AGENDA SECTION: PUBLIC HEARINGS	ORIGINATING DEPT: PLANNING	ITEM NO. <b>E-9</b>
ITEM DESCRIPTION: <i>Revised</i> Final Plat #03-31 to be known as Crimson Ridge Second Subdivision		PREPARED BY: Brent Svenby, Planner

**RE: Revised Final Plat #03-31 Crimson Ridge Second Subdivision**

Application Number: FP #03-31 Crimson Ridge Second Subdivision  
(REVISED)

SHEET NO. 2 OF 2

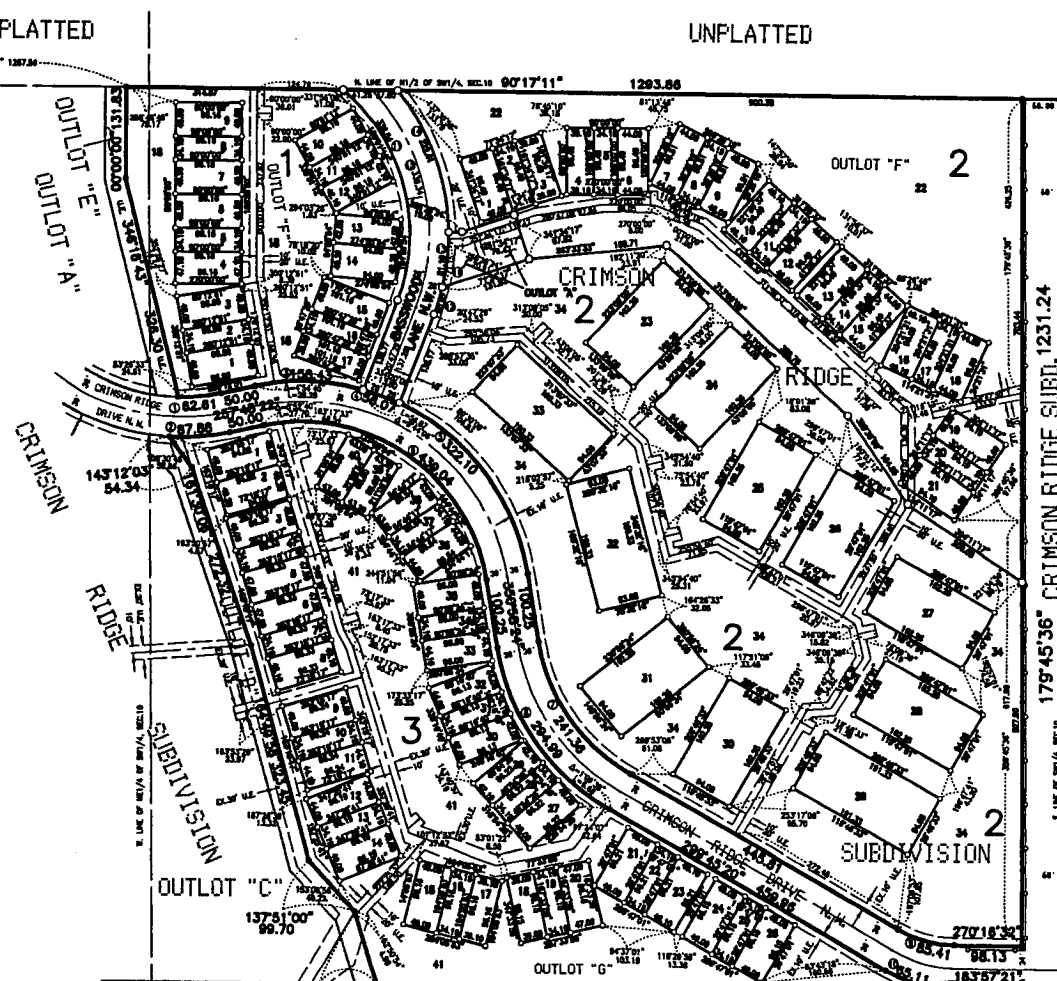
On October 20, 2003 the Council approved the Final Plat called Crimson Ridge Second Subdivision. The plat was approved subjected to 5 conditions. The applicant never recorded the final plat documents. The applicant is wishing to revise the final plat adding lots 23 –34 Block 2. Lots 23-33 would be replated in the future into a condominium plat subdividing the each lot into individual lots once the structure is built. Staff would recommend approval of the revised plat subject to the following conditions or modifications:

1. The ROW for 18<sup>th</sup> Ave NW has been modified as requested in Public Works 10/13/03 comments. Public Works has no new comments based on the plan revisions.

1. Additional utility easements may be required for electrical distribution facilities at the time of development.

- ***Access to Crimson Ridge Second Subdivision and Volunteers of America shall be combined as approved by access permit.***
